Response to science related RIXes

Validation of scientific requirements

Jean-François Glicenstein, IRFU
Online NectarCAM meeting, 6/04/21

Thermal tests

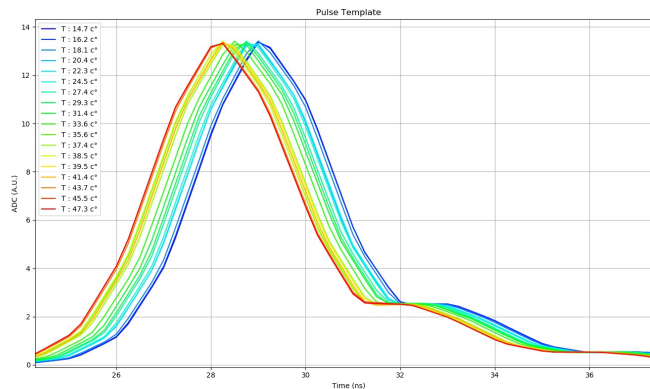
- *RIX 42662*: (GH, RZ)
- Question: temperature stability of calibration parameters, linearity, threshold, etc : How stable does the temperature inside camera need to be for stable operation and parameters?
- Known effects: pedestals (corrected), gains, timing.

- Action: tests (single module+ on whole camera)
- Remark, flasher output also likely temperature dependent.

Ageing of light pulsers, recalibration

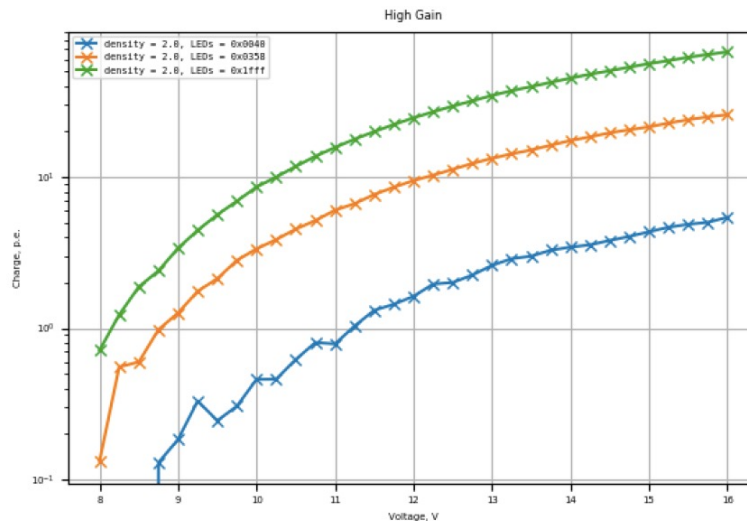
- RIX 42485: (FD)
- Light pulser calibration not required for flat-fielding, but necessary to test linearity.
- Question: when is it necessary to recalibrate the pulser?

- Action: aging measurement or calculation?

Trigger calibration (1)

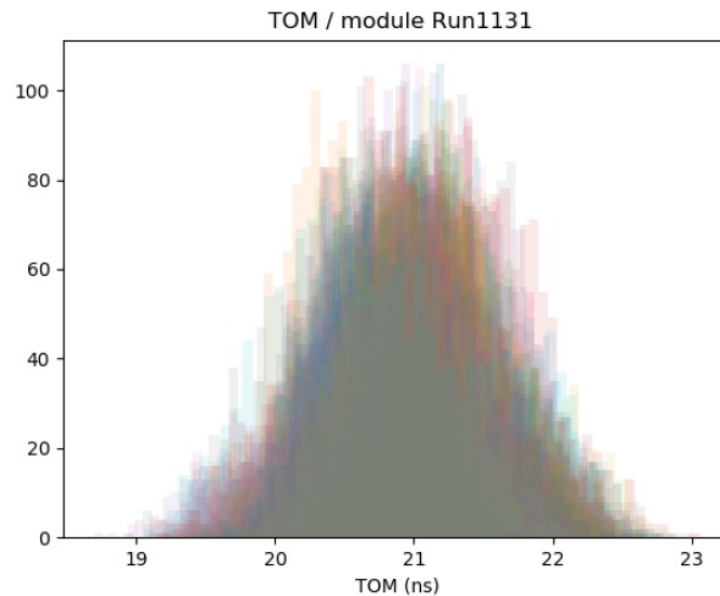
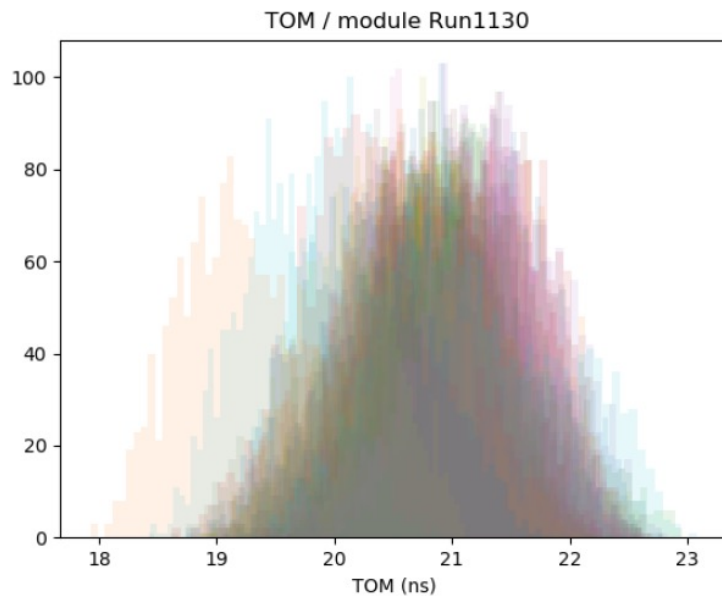
- *RIXes*: 42504 (FD)
- Accuracy of L1/L1A calibration

- Action: More systematic measurement+ documentation

Trigger calibration (2)

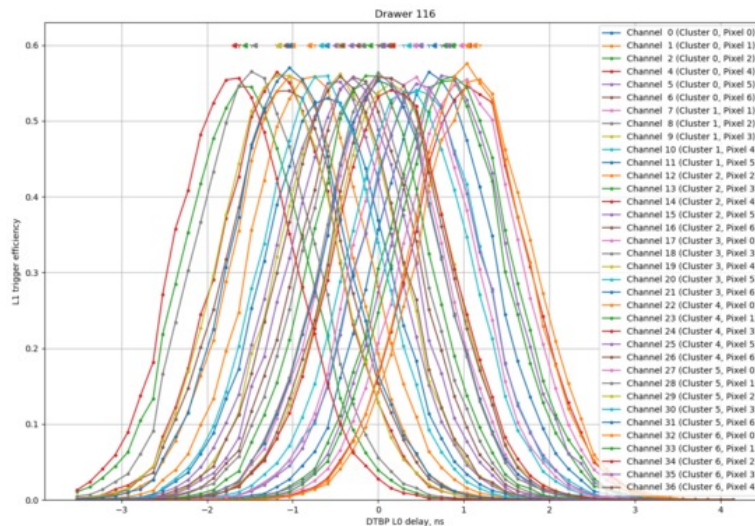
- *RIXes*: 42503, 42507 (FD)
- Time requirement for L0 threshold, delay calibration

- Action: Try dichotomy-like algorithms, less steps, compare with present results

Requirement B-TEL-1260 not met

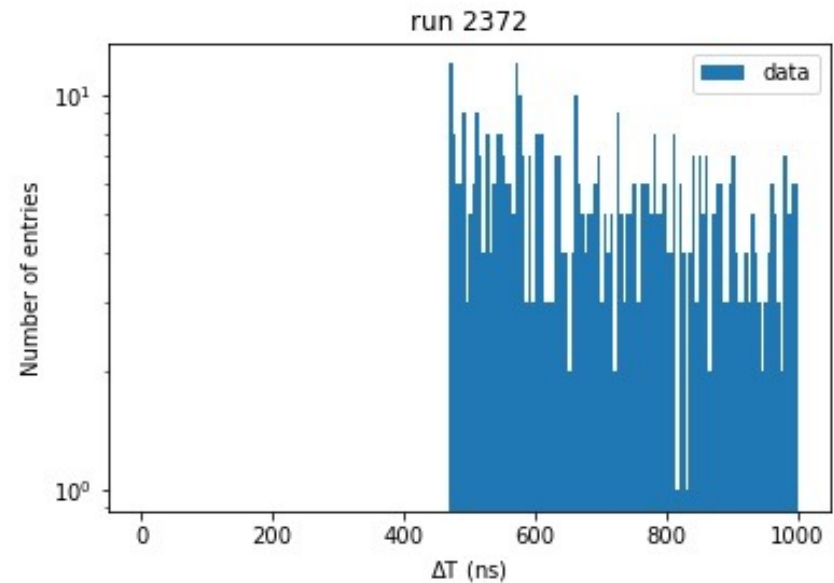
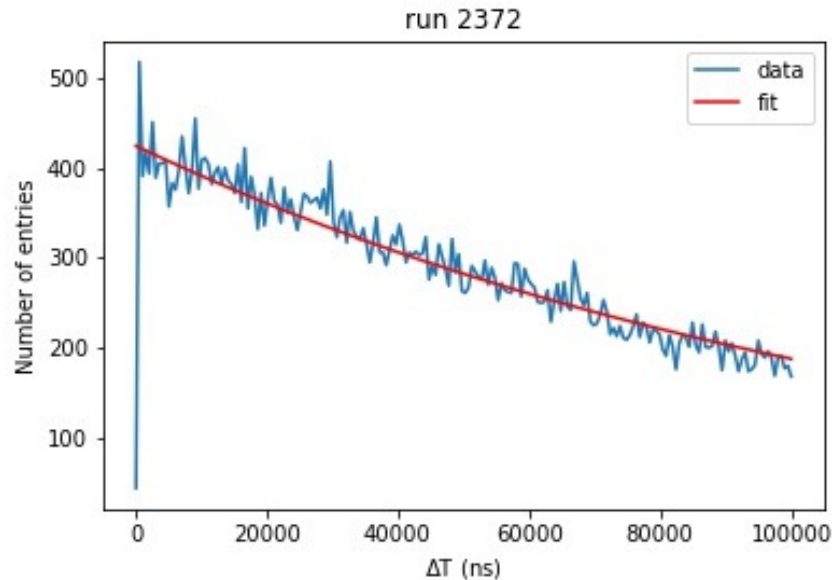
- *RIXes*: 42413 (FD)
- Deadtime is 5.2% at 7 kHz

- Action: validate FEB v6. Test with whole camera.

Electronic bandwidth > 200 MHz

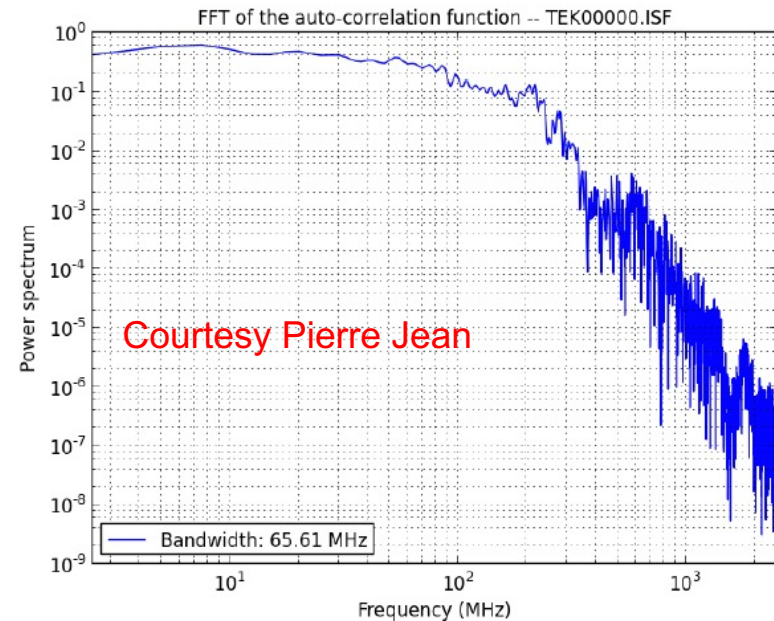
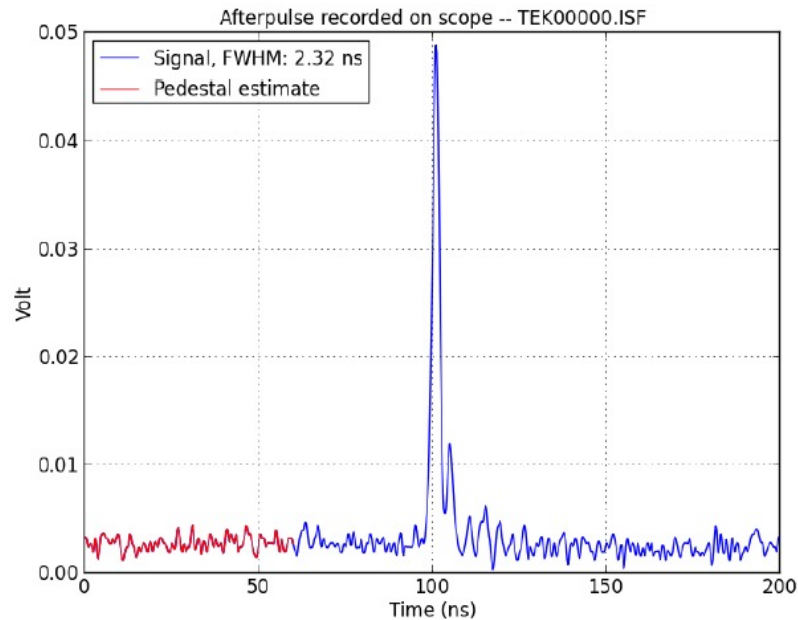
- *RIXes*: 42830 (RM)
- Electronic BW should correspond to the 1 GHz sampling

- should be measured ideally before PACTA
- Action: should try to disentangle the input signal from the electronics.

« Missing » scientific requirements

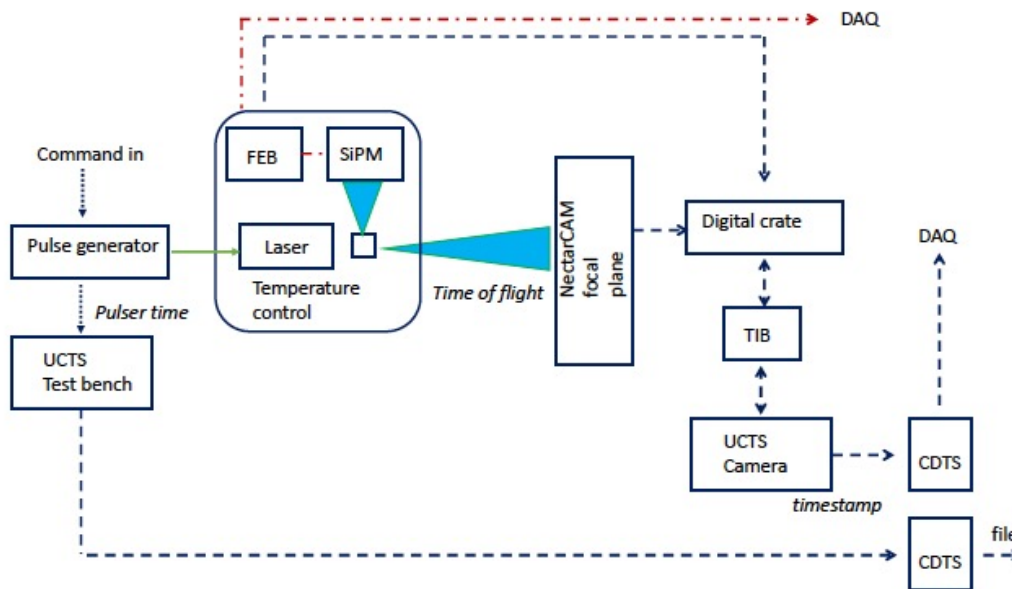
- Some requirements could not yet be validated due to missing hardware or software (RTA):
- B-TEL-1410 and B-TEL-1430, 1440: trigger timing

- Action: test first on tower 66, then on whole camera.
